Proposed Part 8 Residential Development,
Balally, Sandyford, Dublin 16

Architect's Design Report

Dún Laoghaire-Rathdown County Council
August 2024

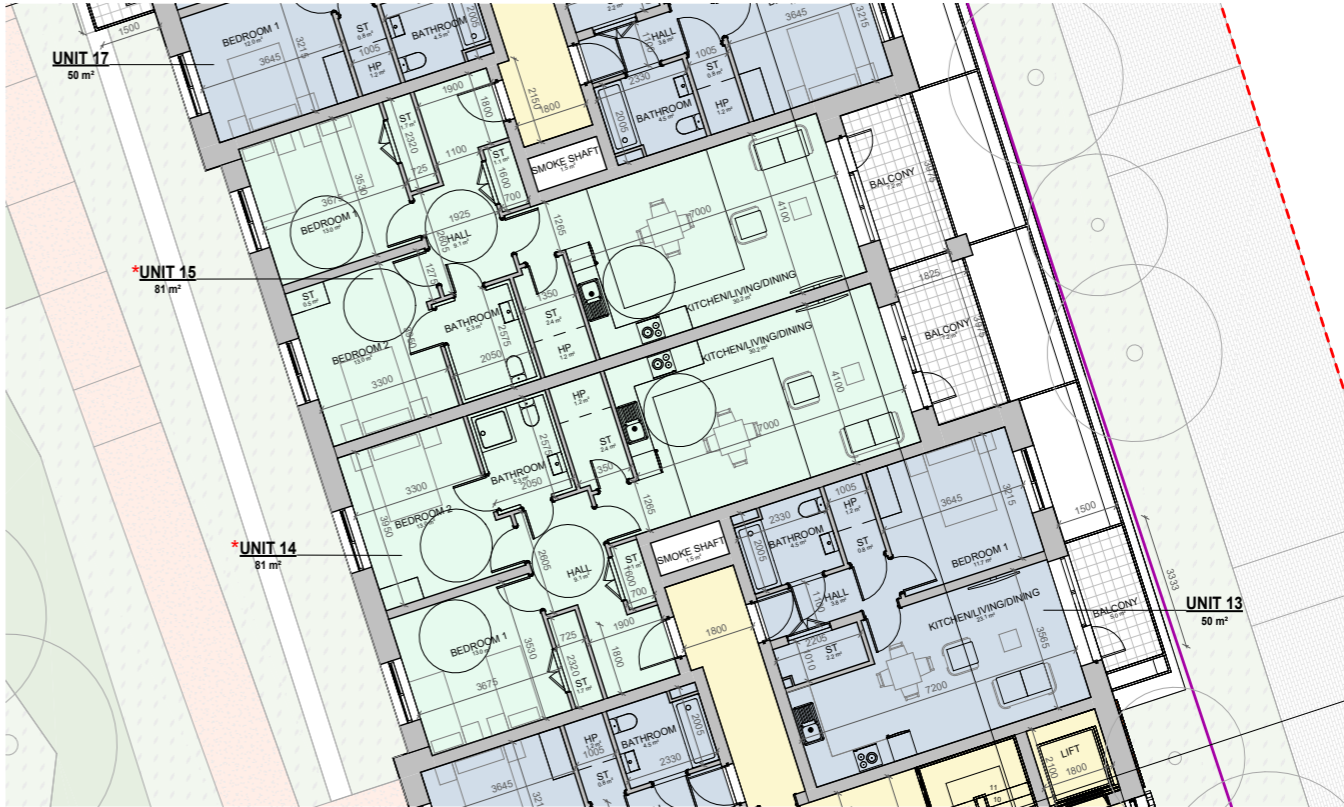
Following the first submission of the design pack on 01/03/2024, we have addressed the comments received from DLR as per the table below		
	DLR Comment	Design Team Response
4	<p>Drainage- The applicant has proposed Cv values of 0.84 for Winter and 0.75 for Summer however reduced runoff rates have been proposed. Appendix 7: Sustainable Drainage System of the County Development Plan 2022-2028 requires that if the applicant proposes to use their own reduced run-off rates, then the default Cv values should be amended to a value of 1.0. Maintaining the default Cv values in conjunction with reduced run-off rates for contributing areas reduces the surface water run-off during hydraulic simulations, resulting in inaccurate simulation results which may lead to under sizing of the drainage system and attenuation storage required. The applicant is requested to clarify if reduced run-off rates for contributing areas have been applied and if so to update the surface water management strategy/calculations as required.</p>	<p>The Cv values used in the Causeway Drainage Software will be amended to a value of 1.0 to comply with Appendix 7 of the Sustainable Drainage System of the County Development Plan because we are proposing to use our own reduced run-off rates.</p>

5	<p>Drainage- The applicant has proposed Cv values of 0.84 for Winter and 0.75 for Summer however, the applicant has used a Soil Type 1, which suggests good infiltration, however one infiltration test failed to produce a result due to failure of the water to infiltrate. The applicant is requested to revise the allowable outflow calculation for the site based on site specific data including soil type and SAAR. The system shall not have an overflow unless deemed necessary by soil infiltration testing results. Any overflow shall be limited to QBAR (calculated using site specific data) or 2l/s/ha, whichever is greater, subject to the orifice size of the flow control device not being less than 50mm in diameter. Note that in the interest of clarity where the calculated QBAR rate for the site is less than 2 l/s/ha then a minimum value of 2 l/s/ha should be applied, not a flat rate of 2 l/s, i.e. the outfall discharge rate should be calculated based on the lowest flow rate achievable for a 50mm Unit Outlet Diameter on the proposed flow control device using an appropriate method such as the Hydro International online Optimum Design Tool. This may result in a change to the attenuation volumes required.</p> <p>Drainage would still say Soil Type 2 is incorrect for the area. Further review to take place when the detailed design comes in.</p> <p>The Soil Type should be based on site investigation.</p>	<p>The Soil Type will be changed to Soil Type 2 due to the result of the site investigation. The outfall discharge rate has been recalculated with the correct QBAR - in this case the calculated QBAR Rate for the site is not less than 2l/s/ha therefore we will use the calculated outfall discharge rate for the site.</p>

6	<p>Drainage- The applicant has analysed the proposed drainage network with a limited number of storm durations. For completeness, all storm water durations, up to an including 10080 mins should be analysed.</p>	<p>The proposed drainage network will be amended to analyse for all storm water durations up to 10080 mins.</p>

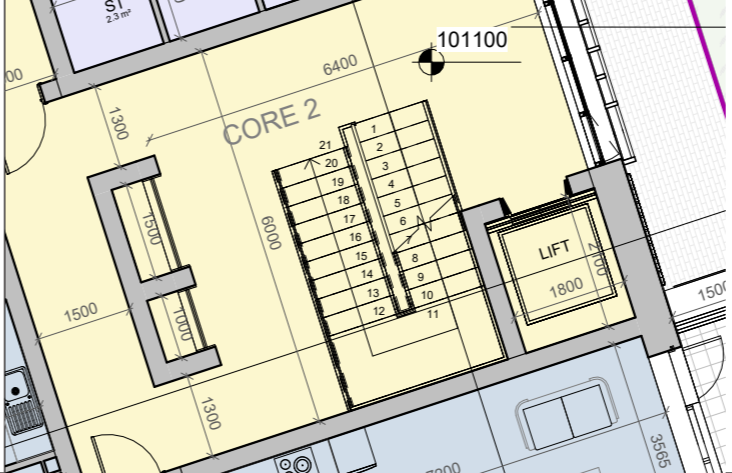
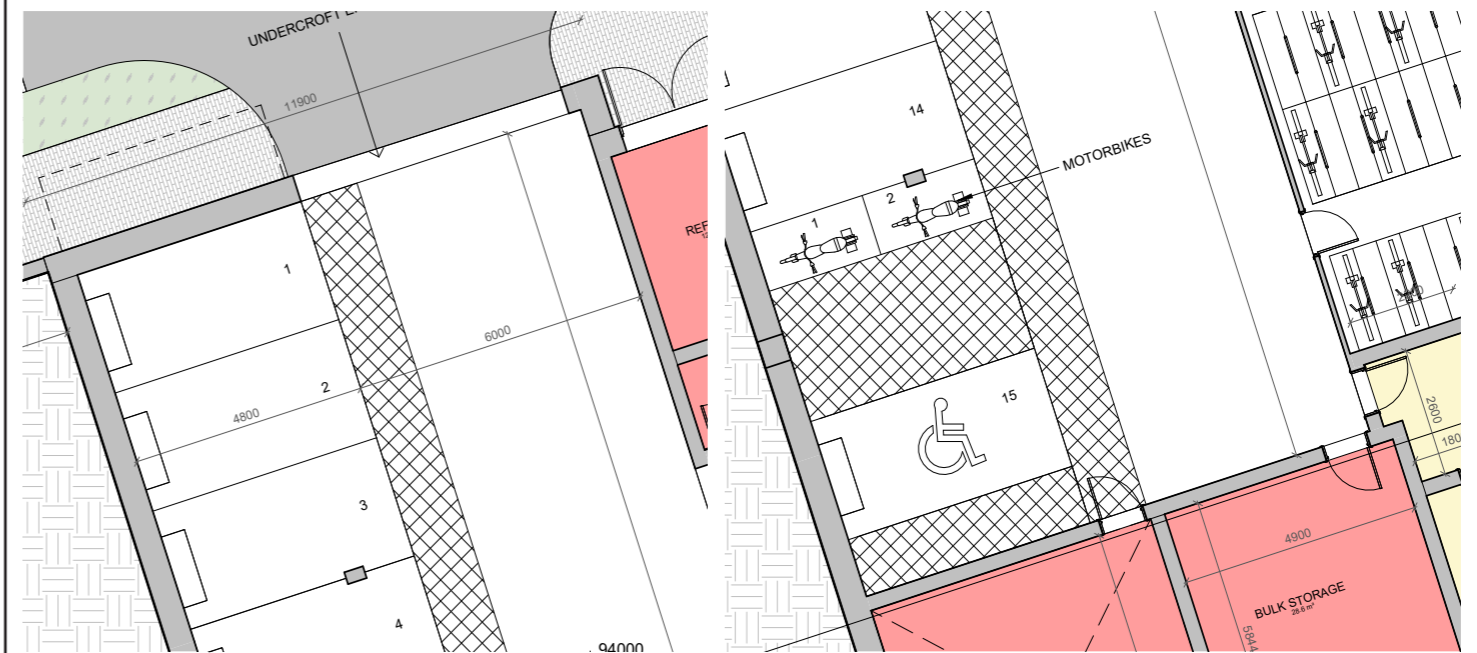
Following the first submission of the design pack on 01/03/2024, we have addressed the comments received from DLR as per the table below		
	DLR Comment	Design Team Response
7	Drainage- Prior to commencement of development the applicant shall submit to the Planning Authority for its written agreement full details of the blue roof drainage network, with outfall to the public network. The drawings should clearly indicate if the roof drainage goes into the drainage network on the ground, and the proposed tank and if so, has this flow been considered in the design of the attenuation tank. Note a separate discharge may be possible, however the allowable outflow for the entire site should be limited to Qbar or 2l/s/ha, as standard.	The engineering report will be updated to include a clear statement on the blue roof drainage. The proposal is that a percentage of the overall roof will be a green roof underlaid by a storage medium so that it also performs as a blue roof, capable of attenuating rainwater. The proposed green/blue roofs will provide initial storage of rainwater, while also reducing the rate at which rainwater from heavier rainfall events discharges to the attenuation system. Flow restrictor outlets will be provided to control the rate of runoff from the roof. Since the green / blue roofs provide their own attenuation with flow restrictor outlet on the roof, these areas will not drain towards the main attenuation tank located. Runoff from the green / blue roofs will connect to the surface water drainage pipework downstream of the main attenuation tank and associated Hydrobrake.

8	Drainage- Prior to the commencement of development, the applicant shall submit details of the Green Roof to the Planning Authority for its written agreement. The applicant is requested to provide a detailed cross section of the proposed build-up of the green roof, including dimensions and demonstrate that the green roof is designed in accordance with BS EN 12056-3:200 and The SUDS Manual (CIRIA C753). A construction plan and a post-construction maintenance specification and schedule should also be included.	Noted. Drawings will be revised to capture item raised.
9	Drainage- Prior to the commencement of development, the applicant shall submit details of The applicant shall ensure that trees shall not be planted in the area over the attenuation tank. Trees shall be placed at a minimum distance of 2m from the edge of attenuation tanks. Tree protection barriers may be required, depending on the tree species and the expected extent of root spread, to be advised by the landscape architect.	Noted. Drawings will be revised to capture item raised.

10	Drainage- he applicant shall ensure that all drainage works are carried out in accordance with the agreed details and that a post-construction maintenance specification and schedule is implemented on site. Maintenance contractors with specialist training in SuDS care should be used. Thereafter, all elements of the surface water management system shall be maintained at all times in accordance the post-construction maintenance specification and schedule, which shall be included in the site Safety File.	Noted.

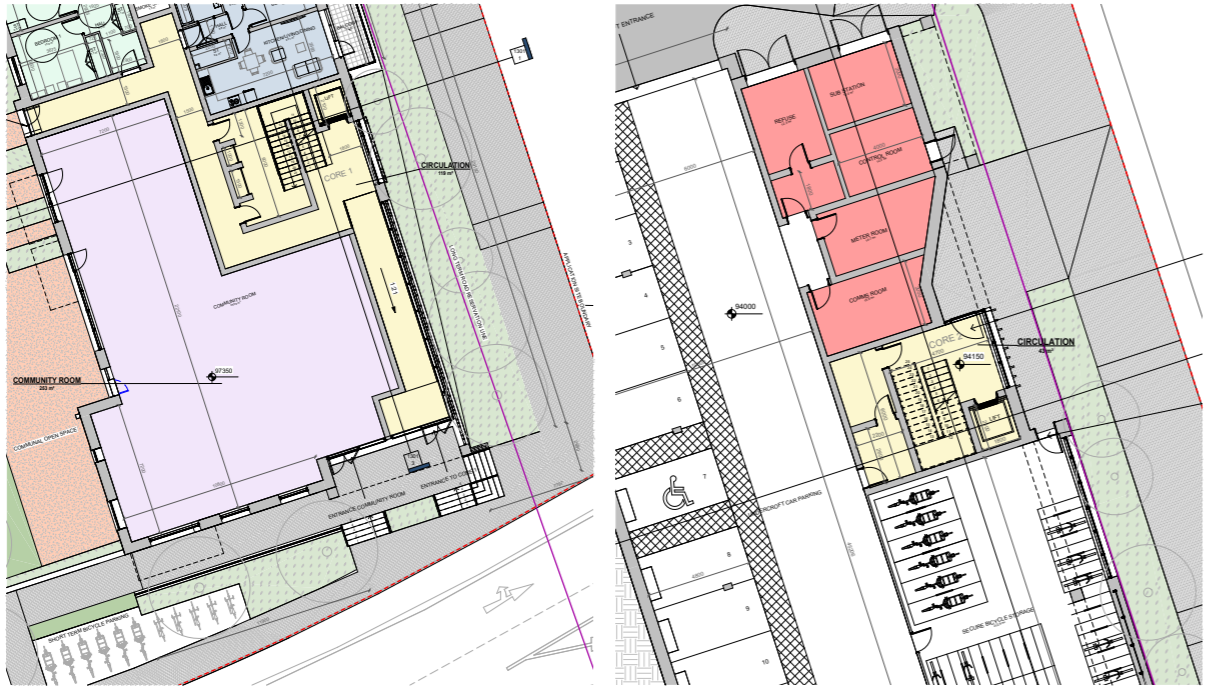
Following the first submission of the design pack on 01/03/2024, we have addressed the comments received from DLR as per the table below		
DLR Comment	Design Team Response	
16	<p>Architects- Sustainability Report- Not specific to the development - mentions housing / apartments and duplexes Need to know specifics for detail design in relation to strategies, heat & ventilation, a number are mentioned, generic in content.</p>	<p>This has been updated to remove any reference to Housing and reissued to Asite. We cannot be more specific as this is a PPP development and PPP Co. are to be given some flexibility in terms of their bid proposals.</p>
17	<p>Architects- Creche- Does this have a tenant? Query size of the creche and is it fit for purpose in relation to the occupier and their model / how is this being funded in relation to social housing? DLR Housing to confirm requirement for crèche in the project brief</p>	<p>Creche is no longer being included in scheme as agreed with DLR Housing. This is now shown as a flexible Community Space which can be fitted out at a later stage.</p>

18	<p>Architects- DLR County Age Friendly Strategy – Universal Design Homes DLR Housing to confirm requirement for provision of UD and Lifetime Home in the project brief is in line with DLR Age Friendly Strategy 2022-2026.</p>	<p>Confirmed as per email from DLR Housing (06/06/2024) that "DLR are happy to proceed with 18% UD at this location".</p>
19	<p>Architects- UD Homes Compliance / General – Apartment Layout Universal Design Guidelines not achieved: -Ensure that double and twin bedrooms are at least 13m² in area. -Provide entrance hallways with a space of between 1500 × 1500mm and 1800 × 1800mm adjacent to the entrance door. -Design the kitchen/ counter layout in a 'U' or 'L'-shape. -Bathroom minimum internal dimensions of 2100 x 2400mm (plans indicate it is 2000 x 2200mm). The plan arrangement not in keeping with Indicative Shower room layout</p> <p>It is worth noting that the apartment layout shown in Figure 24 of the Architectural Design Statement is not the layout shown on the floor plans. The layout shown on the floor plans is even further from meeting the UD Homes guidelines.</p>	<p>Noted- The layouts shall be amended to include the updated 2-bedroom UD apartment type being proposed across the bundle. Also Updated in Design Statement.</p>

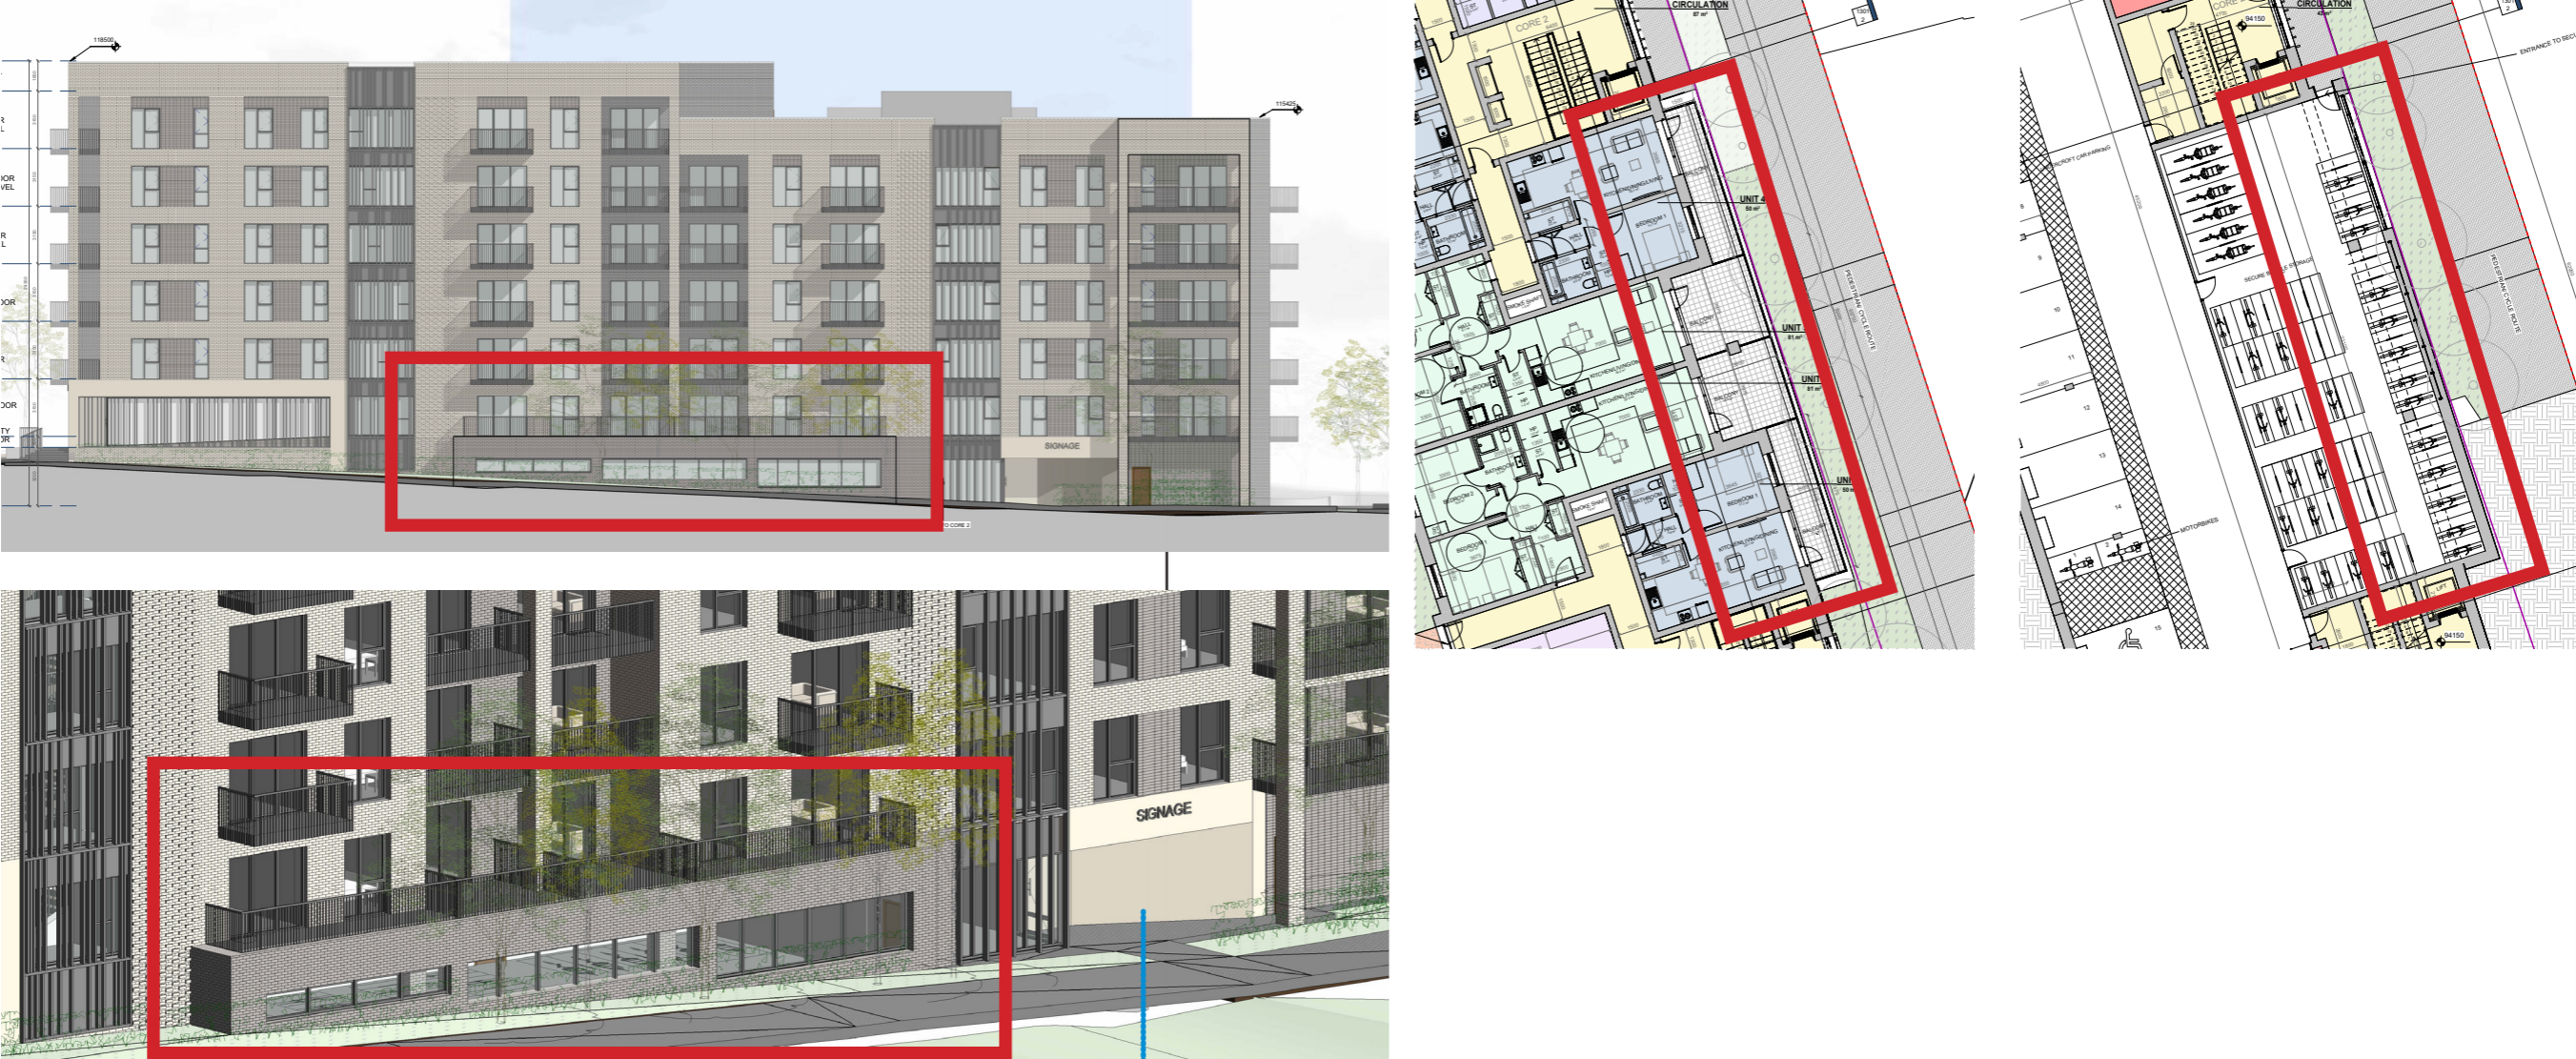
Following the first submission of the design pack on 01/03/2024, we have addressed the comments received from DLR as per the table below	
DLR Comment	Design Team Response
<p>22 Architects- For pedestrian circulation, the ramped approaches to the apartment cores are quite long and convoluted and located around the side of the building.</p> <p>Additionally, the entrances to the building are not readily apparent. Navigability will be challenging for those who are visually impaired or with memory impairment.</p> <p>The UD Homes Guidelines call for the layout of the buildings, roads and streets, and position of signage in a new development should make it easy for everyone to find their way around. In the view provided, taken from Blackthorn Drive and the Drummartin Link Road, the proposed entrances to the main stair cores have little or no presence.</p> <p>Similarly, when looking at the southern elevation there is no indication as to where the approach to the main stair core is located. Site navigability would be challenging to find for those visiting the building, whether or not they had and impairment to their sight.</p> <p>Providing signage/ additional features to augment the presence of the entrances seems a less than ideal solution to this issue. Please provide details of what features you propose along with potential amendments to the design to improve navigability and wayfinding in the Development.</p>	<p>The CGIs shown form part of the verified views pack, and are to primarily illustrate the visual impact on its context. Therefore, the northern entrance is located behind the existing fence and hedge in the foreground.</p> <p>We have reviewed both the approaches and entrances to the 2 main residential cores into the building as follows-</p> <p>Core 1 South has been reconfigured so that the main entrance point is now at the front of the block adjacent to an updated entrance into the Community Room. This caters for Part M accessibility as there is an internal slope that brings you from the door to the upper level where the lift and stair is located. This route is provided with full height fenestration along the eastern facade of the block allowing generous penetration of natural light into this entrance space.</p> <p>This has been achievable by the removal of the proposed creche, allowing internal space to be reconfigured to allow this access from the front. Accordingly, the access route that ran along the eastern facade of the building has been removed as well as the external steps. The front flight of steps is now repositioned, centred on the main entrances to the south elevation providing greater legibility.</p> <p>Core 2 north is accessed at the lower ground floor level given the fall across the site. We have created a splayed wall effect which creates a sheltered porch area external to this entrance with textured brickwork on the play wall as well as natural stone above the entrance in the same finish as core 1. This area asl provides the access point for cyclists into the secure storage space</p>

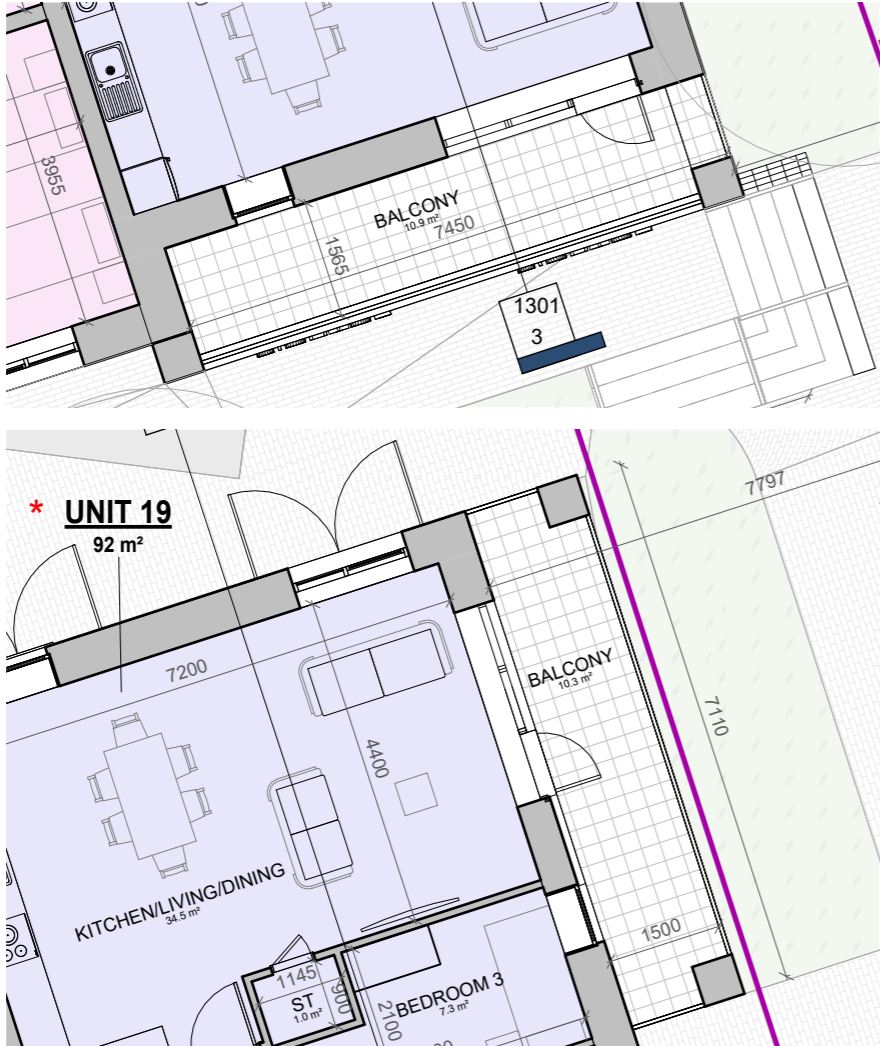
Following the first submission of the design pack on 01/03/2024, we have addressed the comments received from DLR as per the table below	
DLR Comment	Design Team Response
<p>23 It is very difficult to determine what the accessible route is on the Ground floor plan; see below. The ramp seems circuitous; with the starting point of the ramp being visually divorced and physically remote from the entrance to the building. We would be concerned that this approach is not in compliance with Universal Design Principles, which note:</p> <p>"Wherever possible, the top and bottom of a ramp should be adjacent to the top and bottom of an associated flight of steps.</p> <p>The location of stepped and ramped routes should be clearly obvious. Where steps and ramps are provided to gain access to a building entrance, they should both be clearly visible from the approach route."1</p> <p>Similarly, the Irish Wheelchair Association guidelines state:</p> <p>The route to the principal entrance of a building, from all areas, including the car parking area, should be clearly identified and well-lit [...]</p> <p>The steps and ramps should be as close as possible to each other."2</p> <p>1 Building for Everyone: A Universal Design Approach</p> <p>2 Best Practice Access Guidelines 4-Designing Accessible Environments – Irish Wheelchair Association</p> 	<p>See response above with updated layout at this location.</p> <p>Further information below to explain the revised entrances;</p> <p>Left- Upper Level Plan showing new entrance to southern core directly from southern facade paired with new entrance to community room within projecting frame feature. External path and steps on eastern facade removed.</p> <p>Right- Lower ground Level Plan entrance to Core 2 and cycle storage.</p> <p>Below, 3d massing model to illustrate further these updates.</p>
